PASSENGER CAR SERVICE LETTER

NUMBER 936 DATE May 22, 1956

SUBJECT ENGINE OIL PUMP RELIEF VALVE TUBE KIT FOR CORRECTION OF HYDRAULIC VALVE TAPPET LETDOWN - 56J GOLDENHAWK

Fig. 1

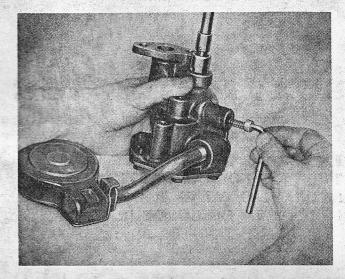
5. Install the relief valve and spring, start the flanged end of the tube in the housing with small end of tube pointing downward. (Toward bottom of pump). (See Fig. 1).

Carefully drive the tube into the housing with the back side of flange just past the cotter pin holes. A tool can be made up locally for driving in the tube by using a small steel sleeve that will fit in the relief valve opening and cutting a slot in the side of the sleeve so it will straddle over the bend of the tube.

FIG. 2

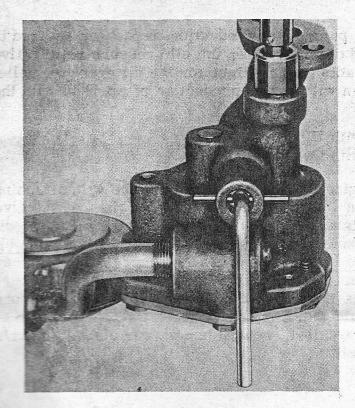
Drive a roll pin in each side of the cotter pin hole with their inner ends just touching the tube to hold it in place. (See Fig. 2).

FIG. 3

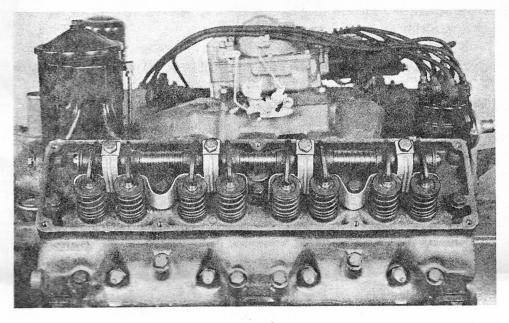
B. Position the baffles on rocker assembly, lining the bolt holes on baffle with bolt holes on rocker brackets. (See Fig. 3). Replace rocker assembly on cylinder head. Replace the rocker shaft bolt lockwasher with the square type lockwasher. Install the rocker shaft bolts, make sure the push rods are

in the sockets of the levers and torque tighten the rocker shaft bolts 55 to 60 ft. lbs. Be sure the square lockwashers do not turn with the bolt, as the baffles might be distorted.
